SUBJECT: WOLF CREEK GENERATING STATION - AMENDMENT NO. 2 TO FACILITY
OPERATING LICENSE NPF-42

KANSAS GAS & ELECTRIC COMPANY
KANSAS CITY POWER AND LIGHT COMPANY
KANSAS ELECTRIC POWER COOPERATIVE, INC.
WOLF CREEK GENERATING STATION
DOCKET NO. 50-482
AMENDMENT TO FACILITY OPERATING LICENSE

Amendment No. 2
License No. NPF-42

SAFETY EVALUATION BY THE OFFICE OF NUCLEAR REACTOR REGULATION

FIGURE 6.2-1 OFFSITE ORGANIZATION

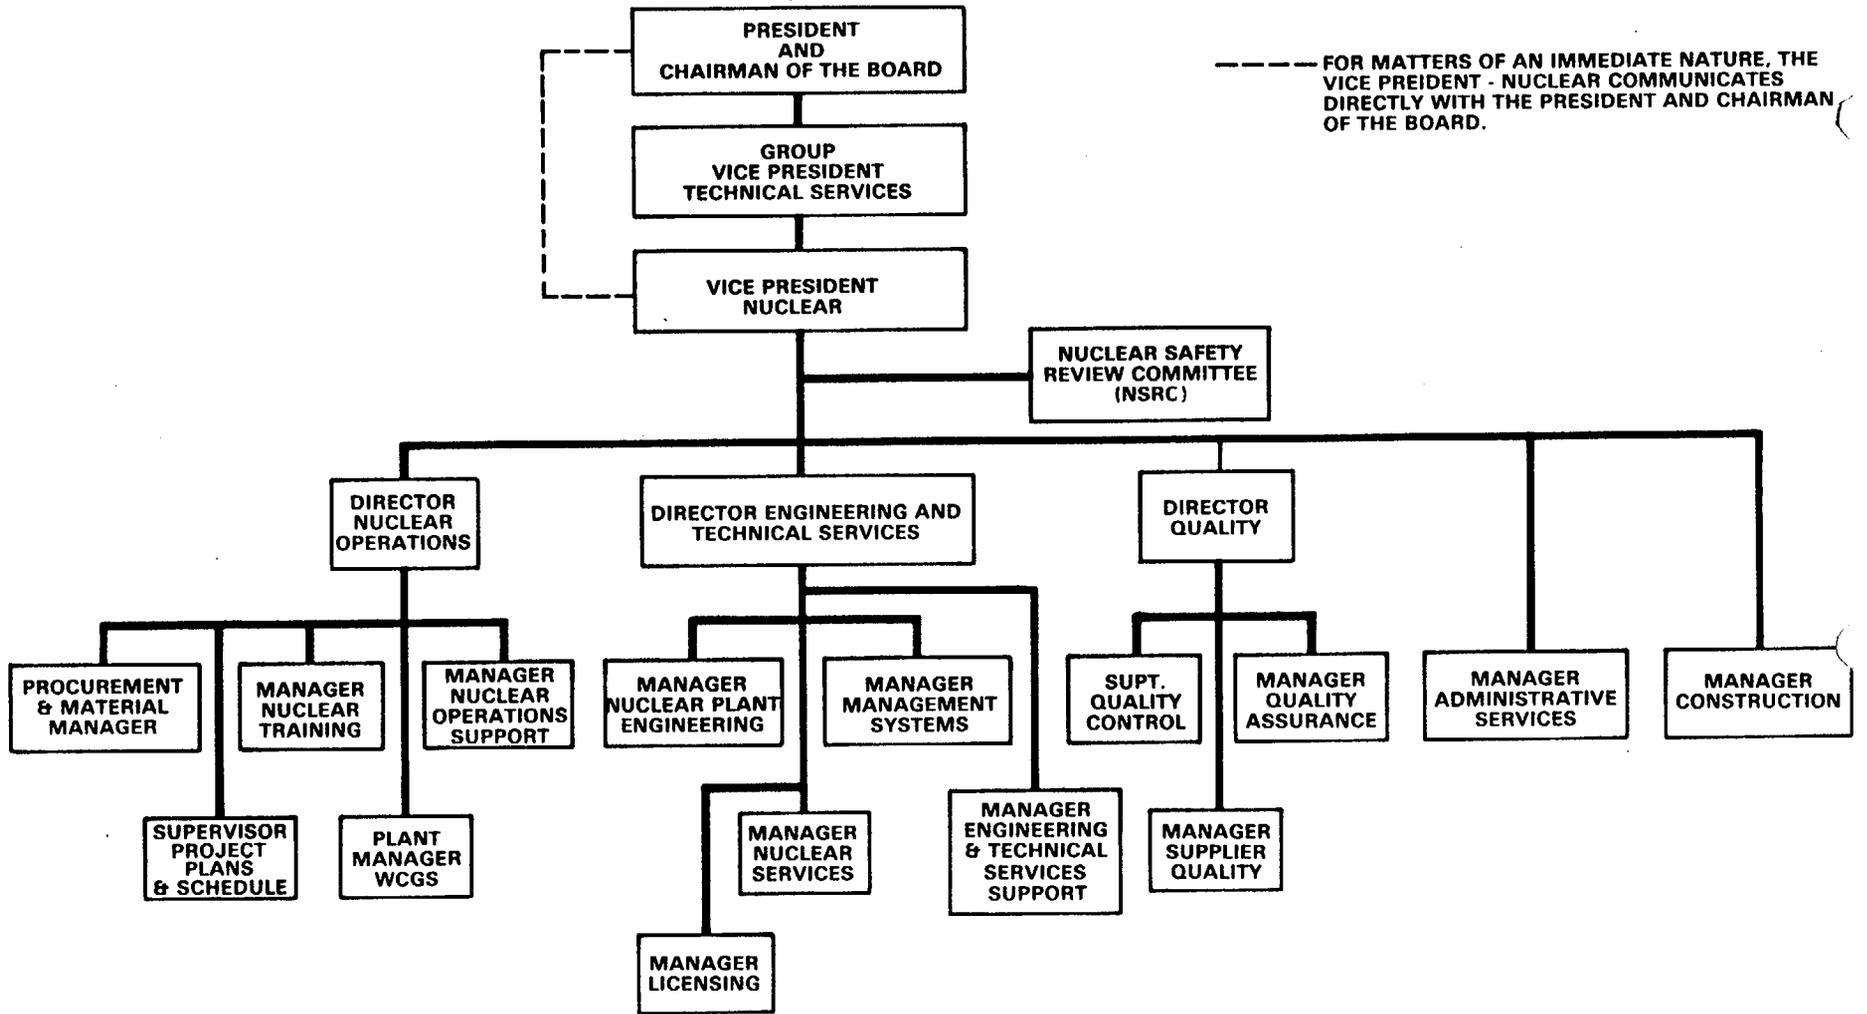
The first requested revision would change the title Procurement & Materials Superintendent, Figure 6.2-1, to Procurement & Material Manager. This is an administrative change that does not constitute a change in reporting relationships or overall organizational commitments and is, therefore, acceptable.

Another revision requested by the July 29 letter would change the title Manager Construction shown in Figure 6.2-1 to Manager Facilities and Modification. This is an administrative change that does not constitute a change in reporting relationships or overall organizational commitments and is, therefore, acceptable.

An additional July 29 revision would change the reporting relationship of the Manager Licensing from the Manager Nuclear Services to the Director (Vice President, when the new operating organization goes into effect) Engineering and Technical Services shown in Figure 6.2-1. This does not constitute a change in job responsibilities or overall organizational commitments. This new reporting relationship should enhance the role of the Manager Licensing and provide added upper management visibility of licensing issues. Therefore, we find this revision acceptable.

Three revisions to Figures 6.2-1 and 6.2-2 have been requested in order to indicate positions and groups that have been added to the Nuclear Department organization. In Figure 6.2-2 a Compliance group is being added to the Unit Organization. This group reports to the Supt. of Regulatory, Quality and Administrative Services. The position Supervisor Project Plans & Schedule, reporting to the Director Engineering and Technical Services, and the position Manager Engineering & Technical Services Support reporting to the Director Engineering and Technical Services, have been added to the Offsite Organization shown in Figure 6.2-1. Since these revisions represent organizational enhancements and augmentations and do not affect any existing reporting relationships or overall organizational commitments, we find them acceptable.

FIGURE 6.2-2 UNIT ORGANIZATION

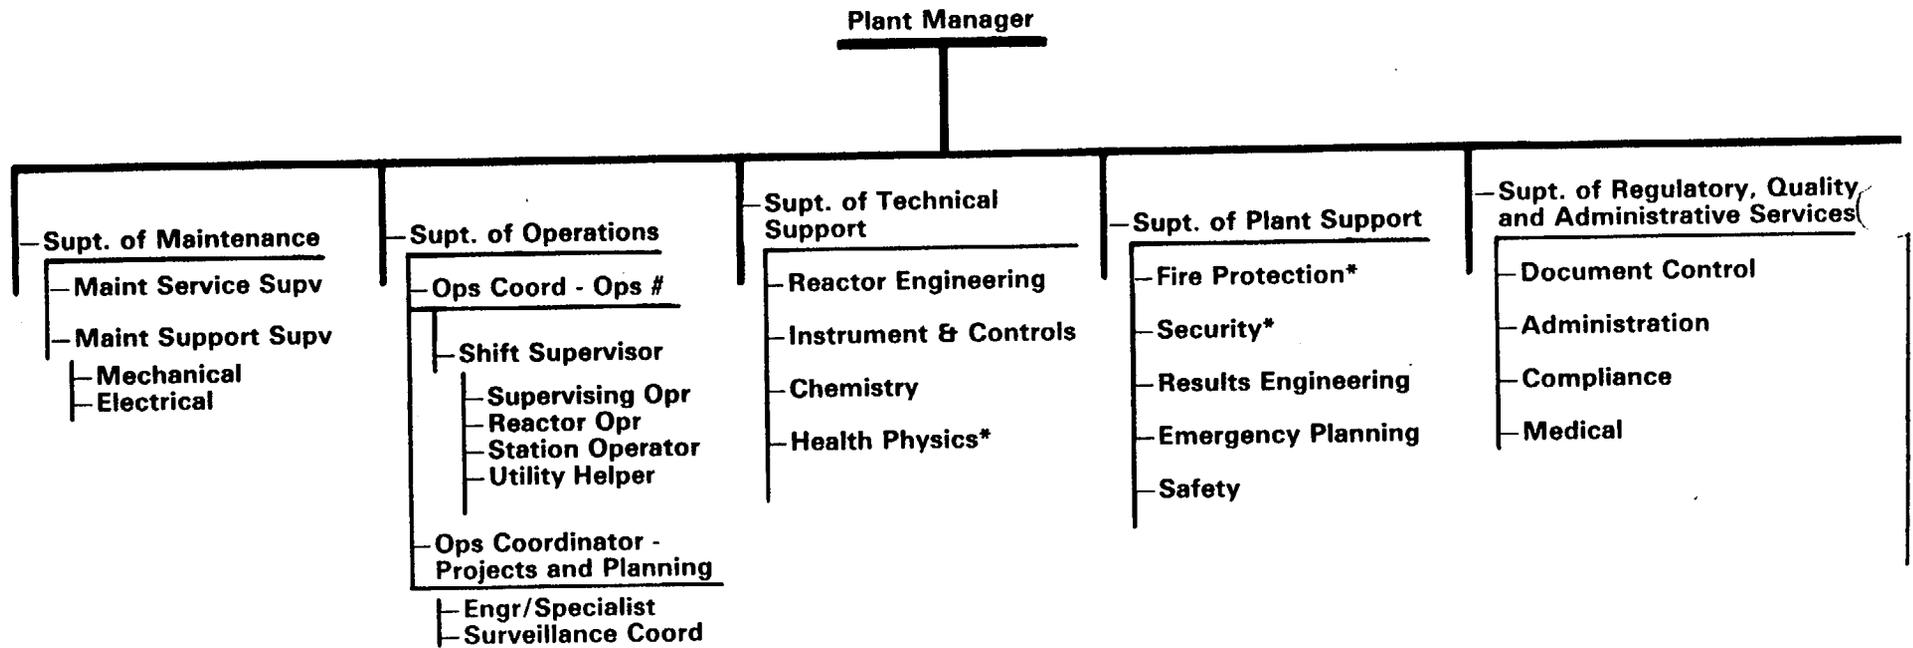
The second revision would change the reporting relationship of onsite Emergency Planning, Figure 6.2-2, from the Supt. of Regulatory, Quality and Administrative Services to the Supt. of Plant Support. This does not constitute a change in job responsibilities, or overall organizational commitments. It does change reporting relationships, but the staff feels that the new relationship will enhance the ability of the Superintendent of Plant Support to manage several related functions in a coordinated way - Emergency Planning, Fire Protection, Security, and Safety. We find this revision acceptable.

The next three changes in the March 4 request rectify clerical errors present in the Wolf Creek Generating Station, Unit No. 1, Technical Specifications. The titles Manager Operations Support, Figure 6.2-1, and Ops Coordinator Planning and Projects, Figure 6.2-2, are being corrected to read manager Nuclear Operations Support and Ops Coordinator Projects and Planning, respectively. In addition, the spelling of Security, Figure 6.2-2, is also being corrected. These changes are acceptable.

The following four changes are being made to Figure 6.2-2 in order to more accurately reflect the organization. The Safety and Medical groups, reporting to the Supt. of Plant Support and the Supt. of Regulatory, Quality and Administrative Services, respectively, are existing groups being added for completeness. The Computers group, reporting through the Instrument & Controls group to the Supt. of Technical Support, is being deleted from the Figure in order to reflect a consistent level of organizational detail. The Utility Helper position, reporting through Ops Coords-ops to the Supt. of Operations, is being deleted since this position no longer exists. According to the licensee, the Utility Helper function is fulfilled by personnel in other existing positions. These changes do not constitute a change in reporting relationships or overall organizational commitments and are acceptable.
